Docket Item # 1
BAR CASE # 2011-0093

BAR Meeting
June 1, 2011

ISSUE: Signage and Awnings
APPLICANT: Lee Choe
LOCATION: 1609 King Street (Uptowner Café)
ZONE: KR / King Street Retail

Figure 1: Proposed Signs and Awnings - Harvard Street Elevation

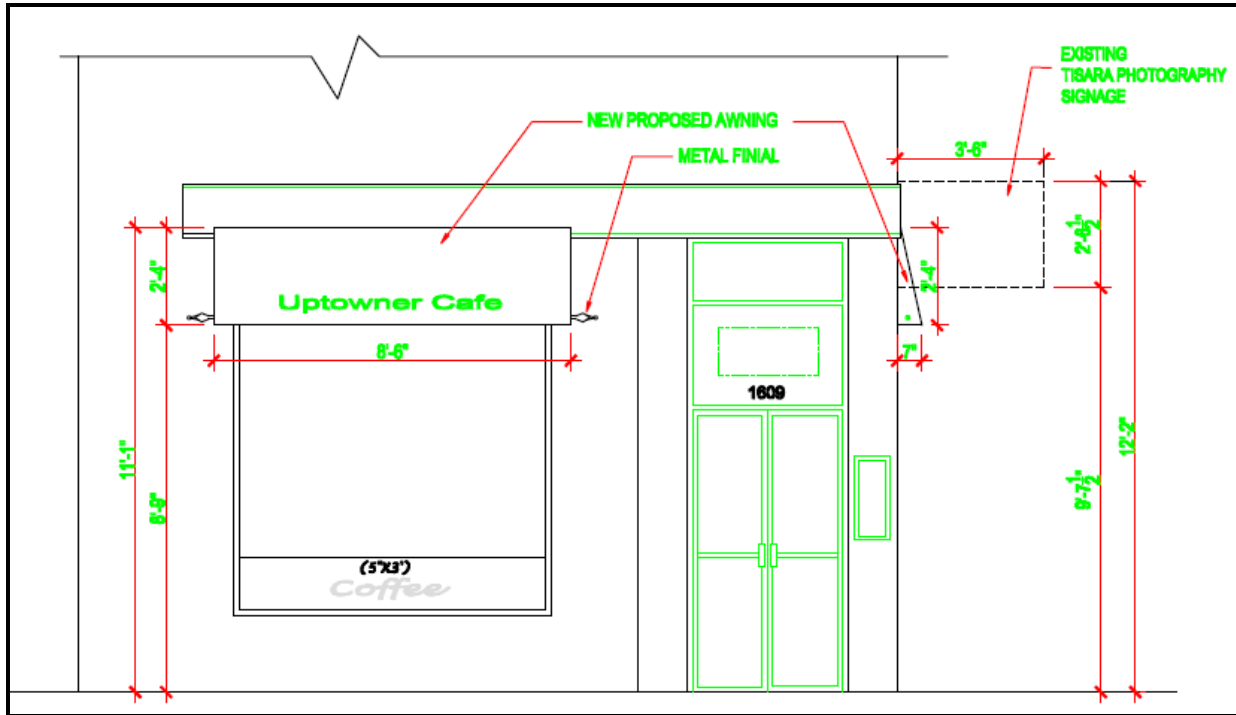
As it is not specified in the applicant's description, Staff recommends a condition of approval specifying that the awnings are anchored to the masonry building through the mortar joints.

C-3 Proposed canopies, wall signs and window sign in angled front window comply. See sign calculations below.

- existing wall sign = 19.25 sq ft
- proposed sign on canopy = 2.5
- proposed window sign above door $= (23.7/2) = 11.85 \text{ sq ft}$
- proposed “coffee” window sign = 1.26 sq ft
- Total signs on Harvard Street = 34.86 sq ft

Figure 2: Proposed Signs and Awnings - King Street Elevation

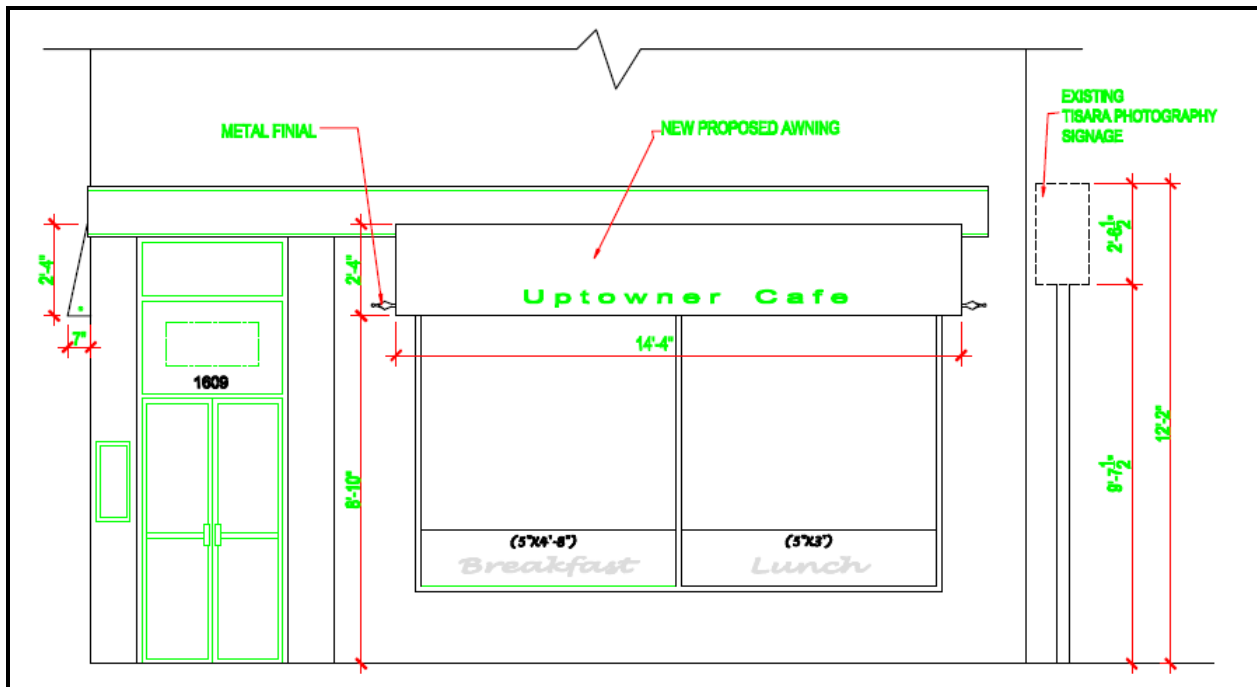
- proposed sign on canopy = 3.95 sq ft
- proposed window sign above door $(23.7/2) = 11.85 \text{ sq ft}$
- proposed “breakfast” and “lunch” window signs = 3.21 sq ft
- Total signs on King Street = 19.01 sq ft

Figure 4: Proposal – Menu Display Case

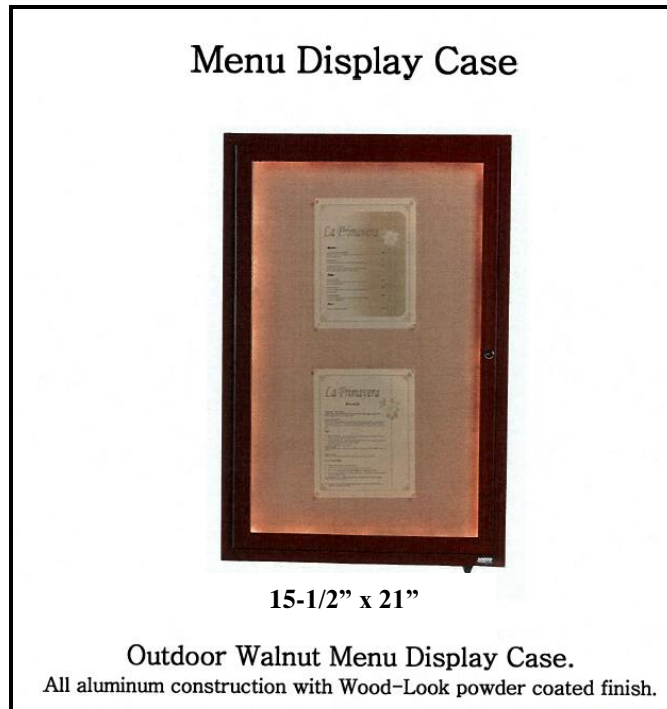
Staff's only concern with the application is with the proposed size of the menu display case. As shown in the below photo, there is a space limitation in the location to the right of the entry door, as the building has brick detailing that needs to remain exposed. Therefore, Staff is recommending that the width of the menu display case does not exceed 14 inches.

1. That the width of the menu case does exceed (14”) fourteen inches.
2. That the awnings are mounted through the mortar joints and not the brick.
3. That the existing hanging sign mounted on the sign bracket is removed.
4. That all the existing window and door signage and vinyl decals are removed.
5. That the menu board is not internally illuminated.
6. That any proposed changes to the exterior lighting will return to the BAR for review and approval.

Figure 5: Proposal – Signage to be Removed/Retained

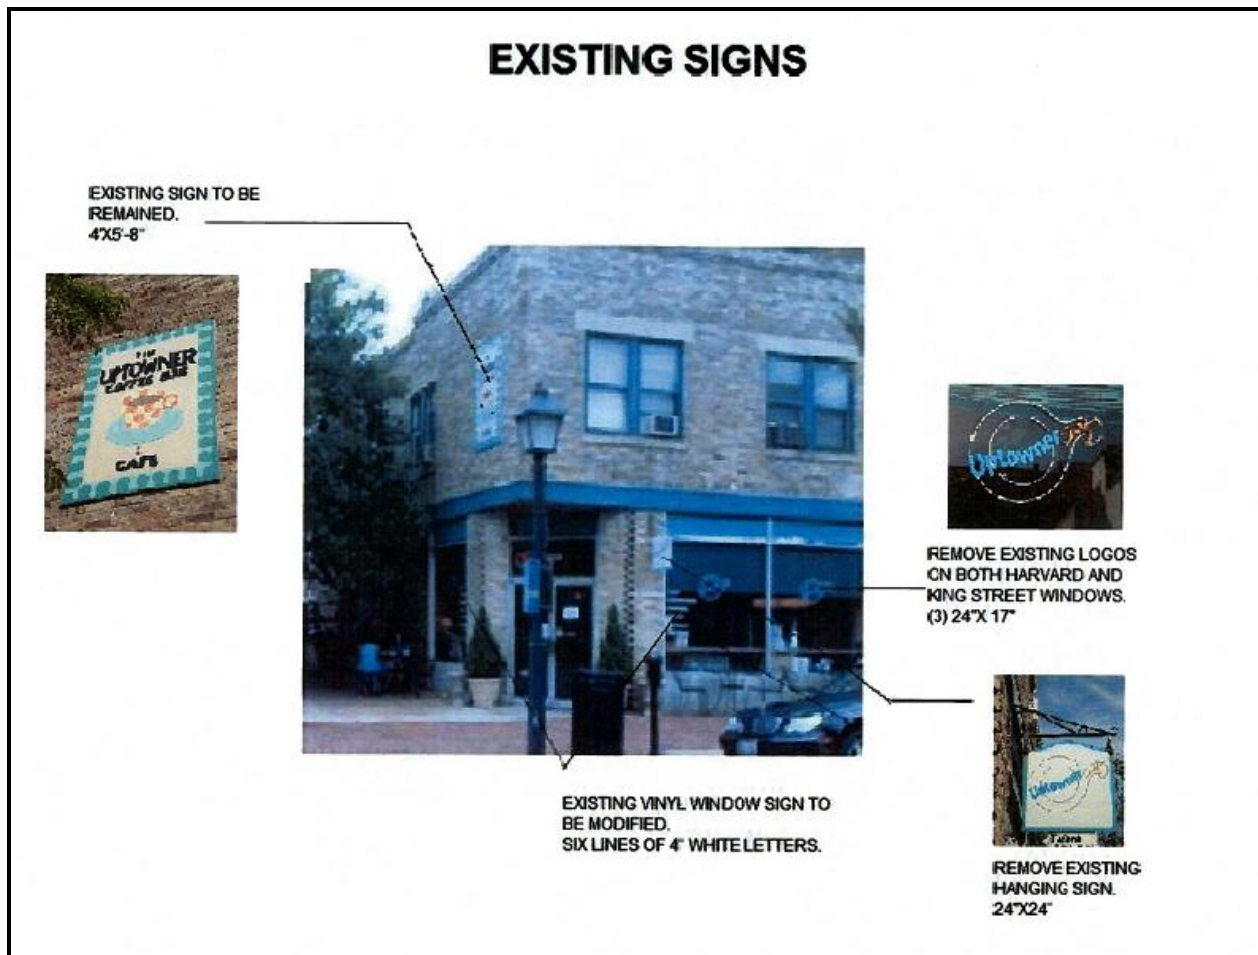
F-1 Existing window signs and hanging sign are to be removed.

C-2 Vinyl window signs with listed food items are special advertising and are not permitted.
